**MEMORANDUM**

**TO:** District of Columbia Zoning Commission  
**FROM:** Jennifer Steingasser, <sup>JS</sup>Deputy Director  
**DATE:** April 14, 2011  
**SUBJECT:** **Setdown Report** for ZC #11-03, Southwest Waterfront  
1<sup>st</sup> Stage Planned Unit Development and Related Map Amendment

Hoffman-Struever Waterfront, LLC, has petitioned the Zoning Commission to setdown their request for a Stage 1 Planned Unit Development (PUD) and related map amendments to construct a mixed-use project on several squares west of Maine Avenue, SW, and on piers over the Washington Channel. As a result of the design of the PUD, three areas of zoning flexibility would also be required. The proposal, consisting primarily of large-scale mixed use buildings, as well as a small number of rowhouses and other smaller buildings, is not inconsistent with the Comprehensive Plan, including the Development Plan and AWI Vision for the Southwest Waterfront. The Office of Planning (OP), therefore, recommends that the PUD and related map amendment application be set down for public hearing. OP further recommends that the Commission set down, in the alternative, W-1 zoning for Parcel 10 and the Waterfront Park

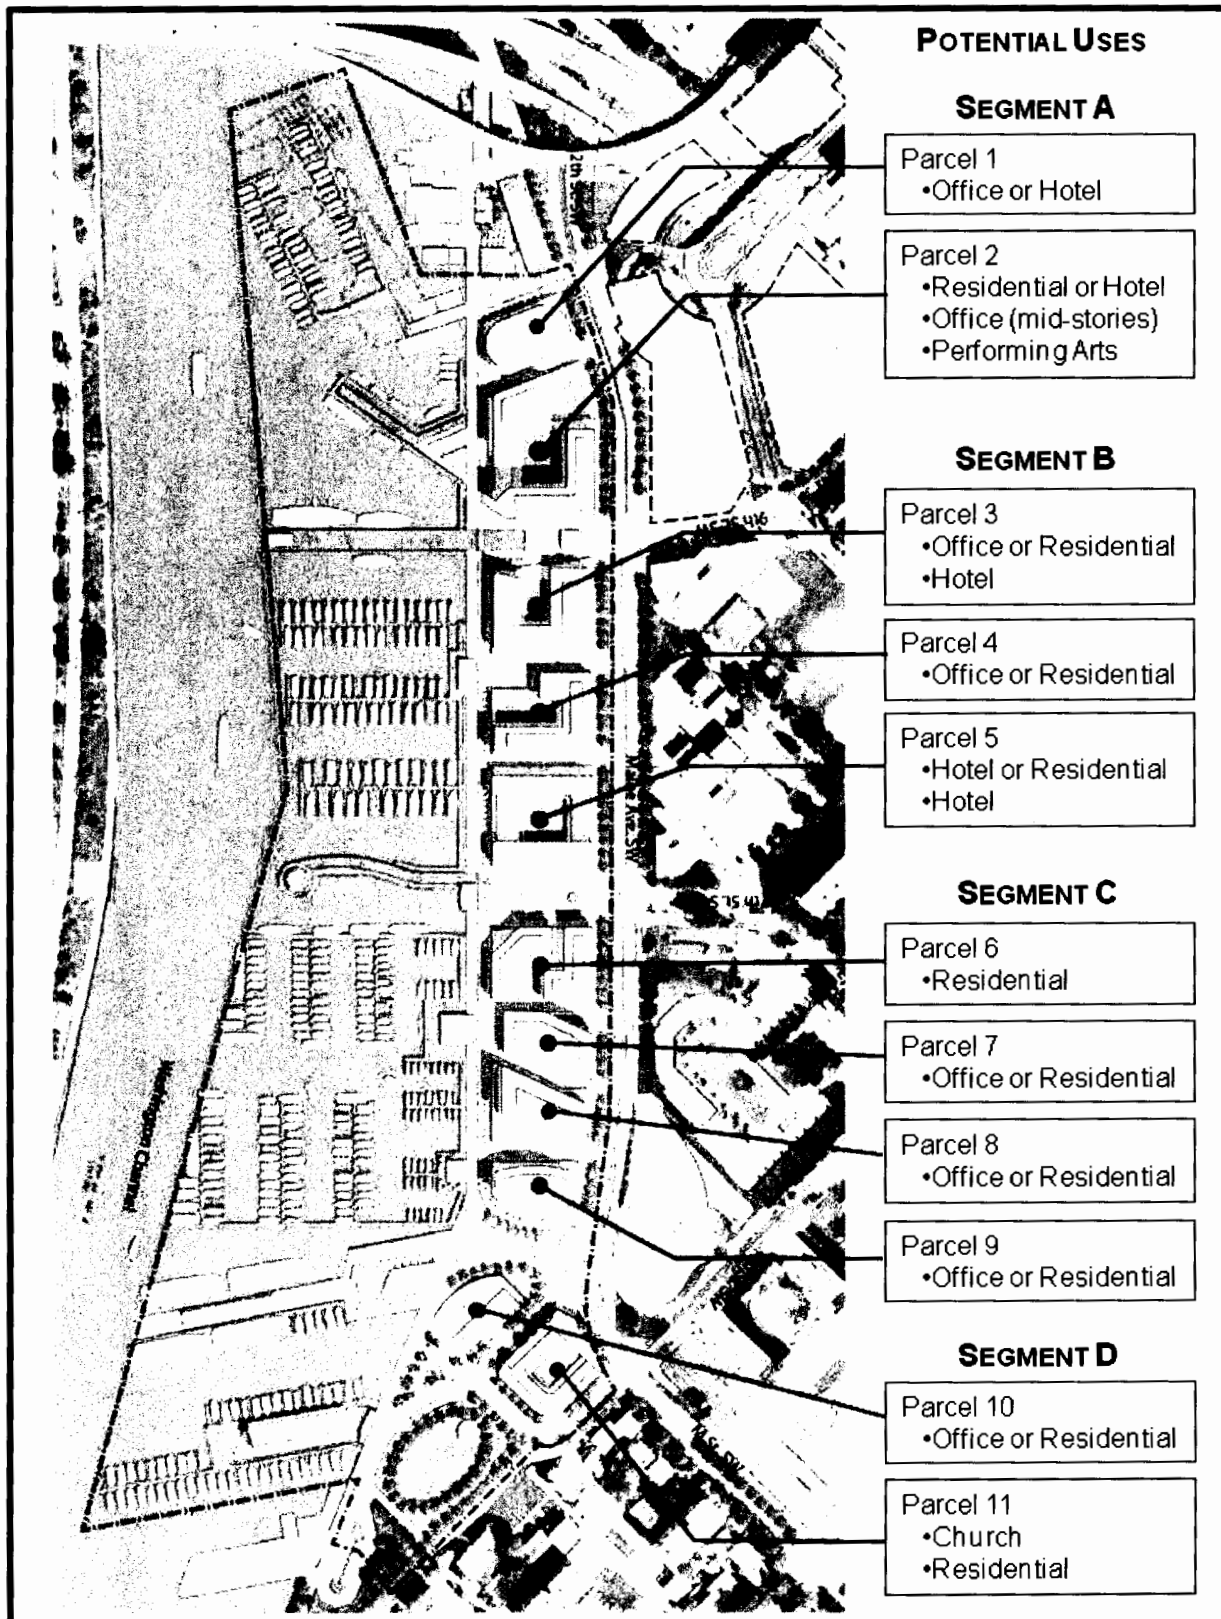
buildings would contain retail uses, and the application also describes potential uses in the upper levels of each building. OP has collated the information on upper story uses and presents it in the graphic on page 5. OP notes that while application data indicates that Segment C could have up to 120,000 square feet of hotel, Sheet 2.7 of the plans shows that residential or office are the only potential uses for each individual building. That discrepancy should be resolved prior to a public hearing.
